PROGRAM INFORMATION BULLETIN NO. P08-17

SUBJECT: Potential Boom Failure on Komatsu America Corp. Model
PC400LC-7L Excavator

CAMPAIGN NUMBER: 7C064 1

SUBJECT: PC400LC-7L REPAIR OF ARM CYLINDER BRACKET ON BOOM. ***NOTE:
EXTENDED COMPLETION DATE 6/27/2008 KF***

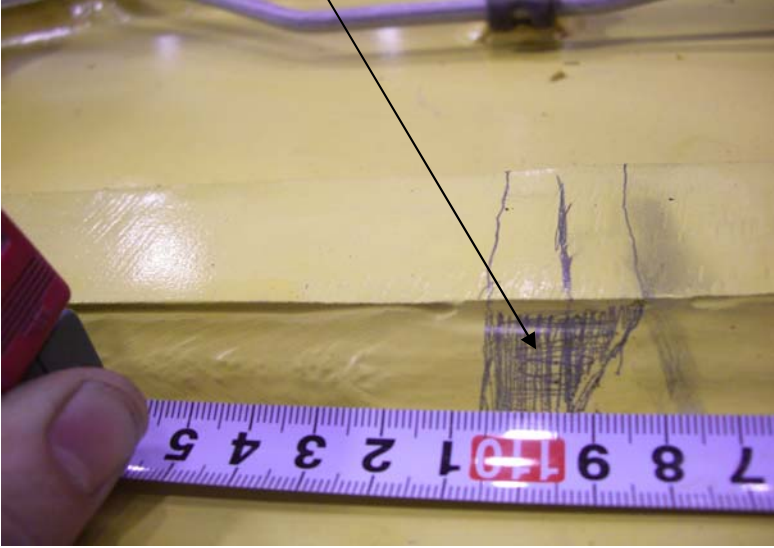
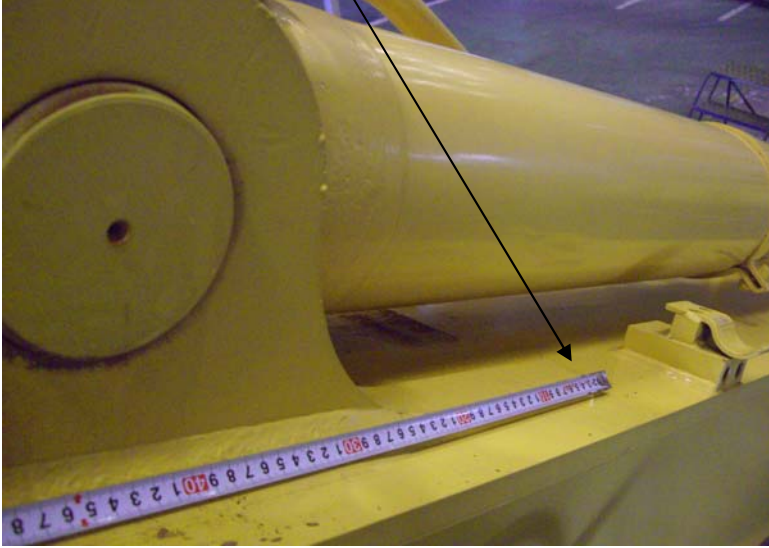
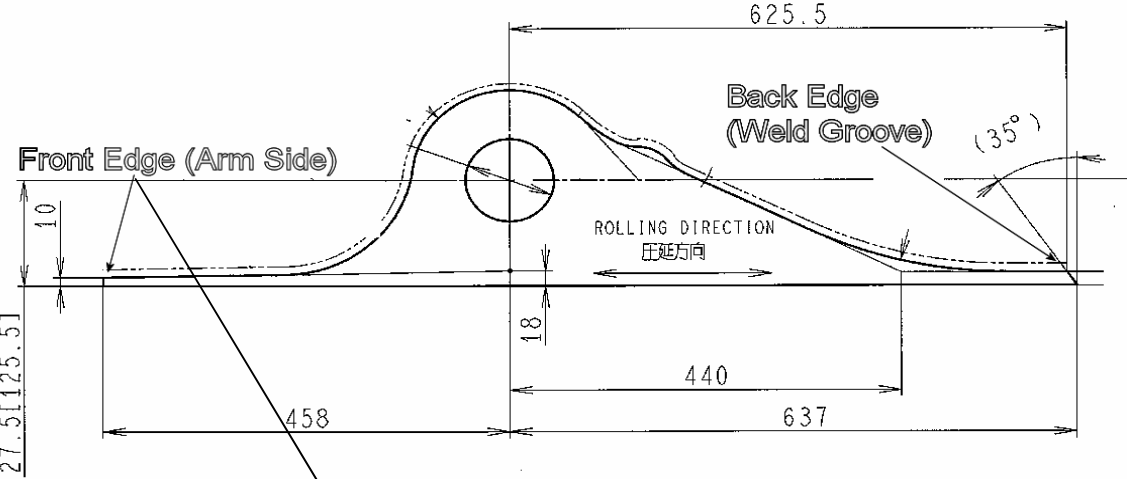
1. Place the machine on level ground and lower boom to lowest possible position.
See Photo 1

2. Remove all hydraulic tube clamp brackets on top side of boom.

3. Without breaking any hydraulic connections, pull tubes off to side of boom and band tie together to make access for weld repair. See Photo 2.

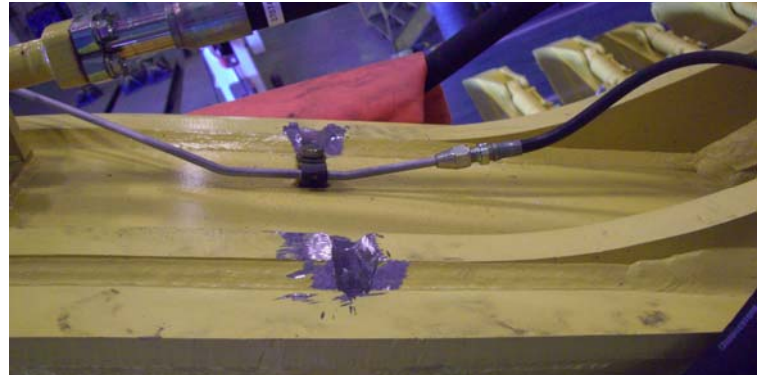
4. Layout and mark area to be ground out.

If there is no visible crack, weld root is 1095 mm from front edge of bracket.

Note: Protect work lamp, hoses, cab etc. from grinding/gouging sparks with fire proof blankets.

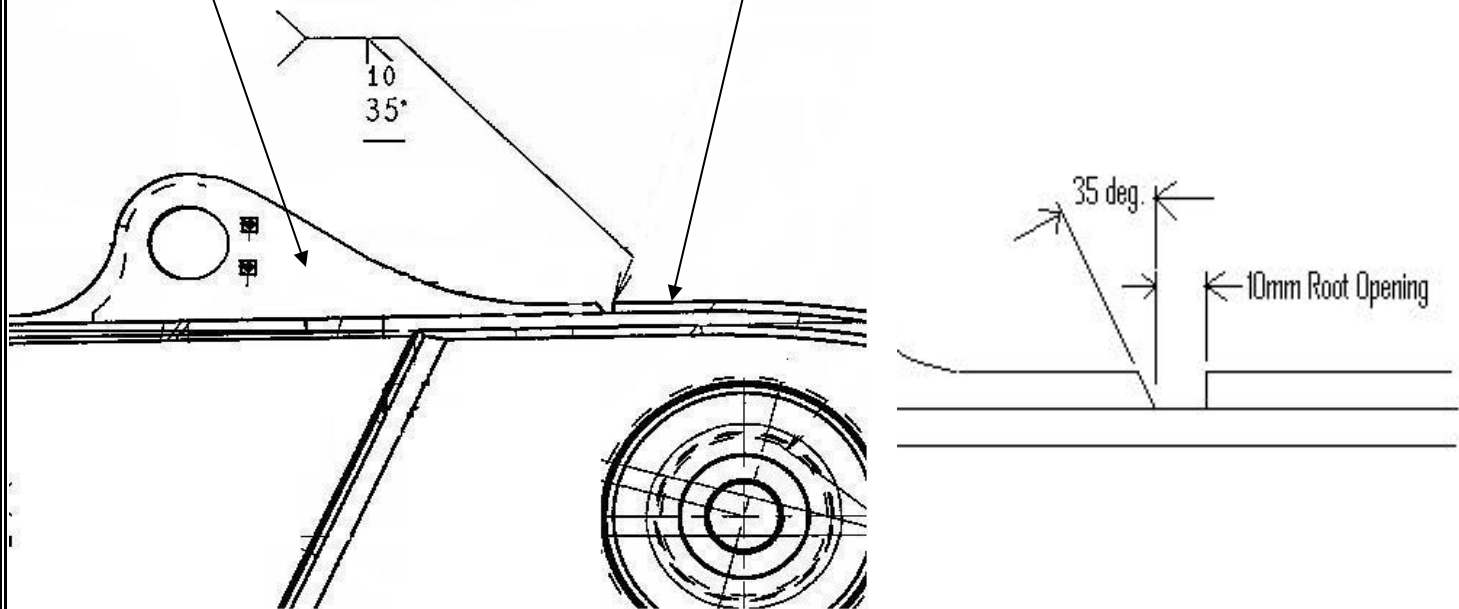
5. Grind out and prepare weld groove as described on page 4.

6. Liquid penetrant (PT) inspect weld groove to ensure top plate is not cracked. *Note: Dye will bleed out between cyl. bracket and top plate and between reinforcing strip and top plate as shown; Check is to ensure there is no crack in fillet welds at side of bracket or in the boom top plate.* **If cracking has occurred in top plate; See page 4/5 for additional instructions.**

Proceed with step 7 if top plate is not cracked.

7. Clean weld groove and weld per page 6 procedure.

8. Grind and paint as shown, reassemble tubes to boom.
